THE CORPORATION OF THE DISTRICT OF BURNABY

TRAFFIC SAFETY COMMITTEE

REPORT OF THE TRAFFIC SAFETY COMMITTEE

APPENDIX "A"

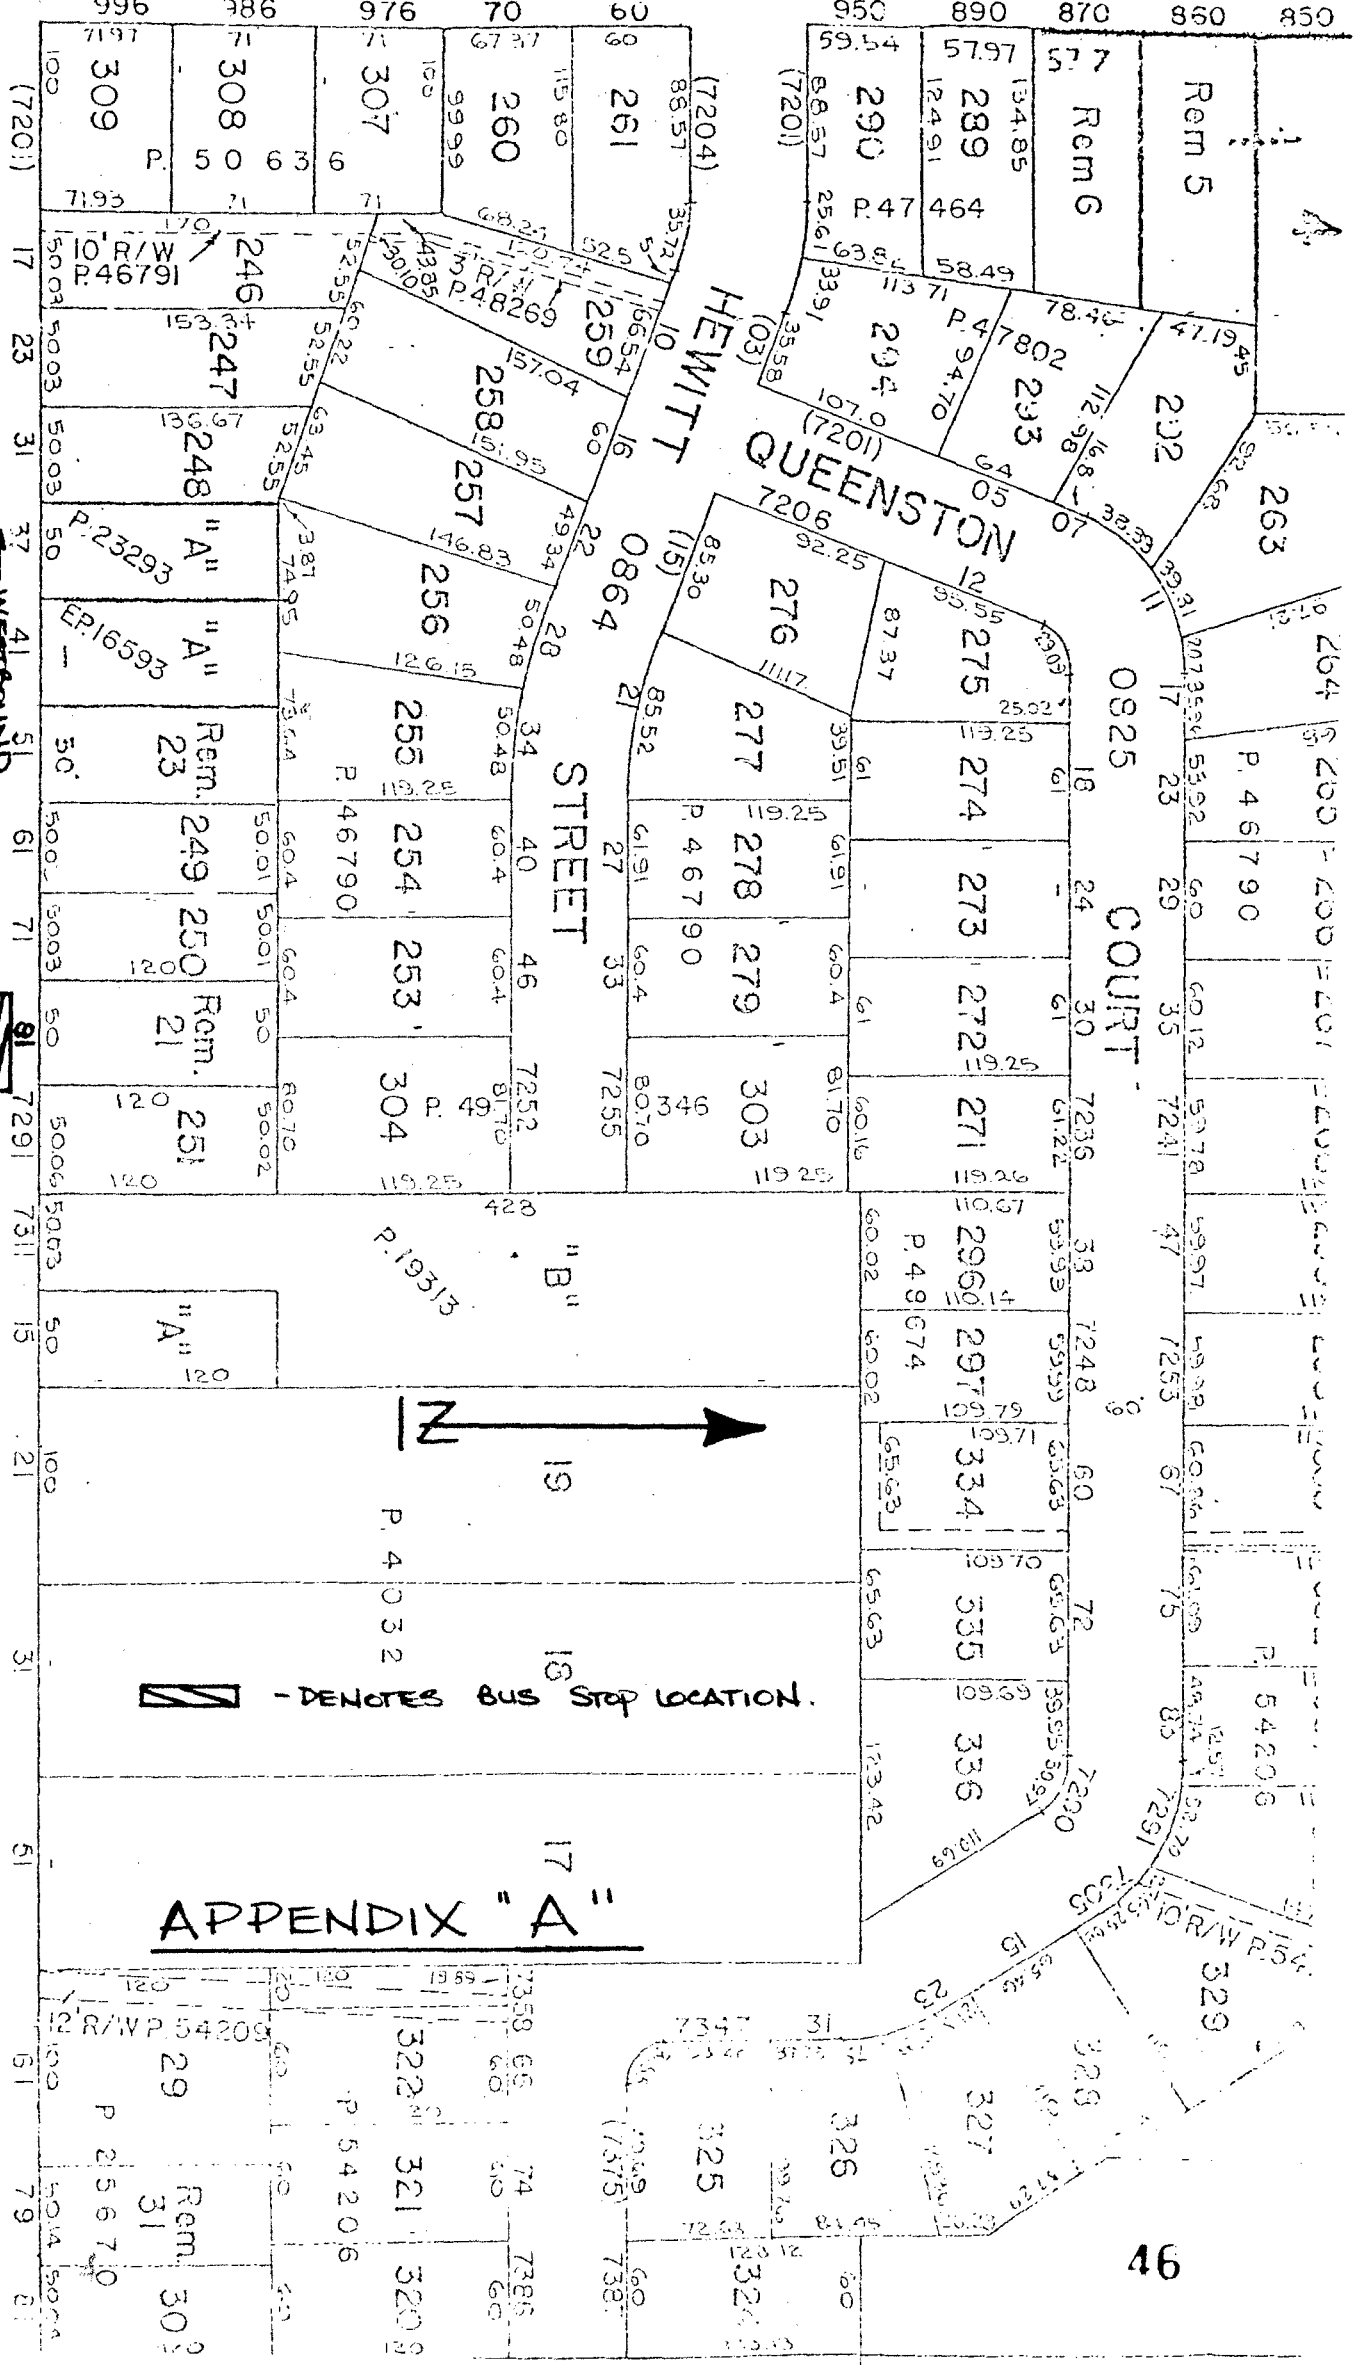
"The captioned request was received from Mrs. Barrington-Foote of 1205 Augusta Avenue. Our investigation of this request found that the requested stops were warranted based upon existing bus stop spacing and the increasing development within the immediate vicinity.

In keeping with policy positions for bus stops, the eastbound stop will be farside Augusta Avenue and the westbound stop position will be in front of 7281 Curtis Street which is farside the Augusta Avenue leg of this 'T' intersection. These stop locations are shown on the attached Appendix 'A'.

These two stops are on a street with gravel shoulders and the volumes on Curtis are high for this standard of street. Therefore, if approved, the Engineering Department will be providing asphalt pull-off areas leading up to the existing concrete sidewalks which will serve as passenger loading areas."

- a) That Council approve the establishment of two new bus stops on Curtis Street at Augusta Avenue, one eastbound Curtis farside Augusta and the other westbound farside Augusta in front of 7281 Curtis Street.
- b) That Mr. J.L. Bates, British Columbia Hydro Transit, 850 Southwest Marine Drive, Vancouver, B. C. V7P 1R8 and Mrs. G. Barrington-Foote, 1205 Augusta Avenue, Burnaby, B. C. V5A 2B5 be notified of this approval.
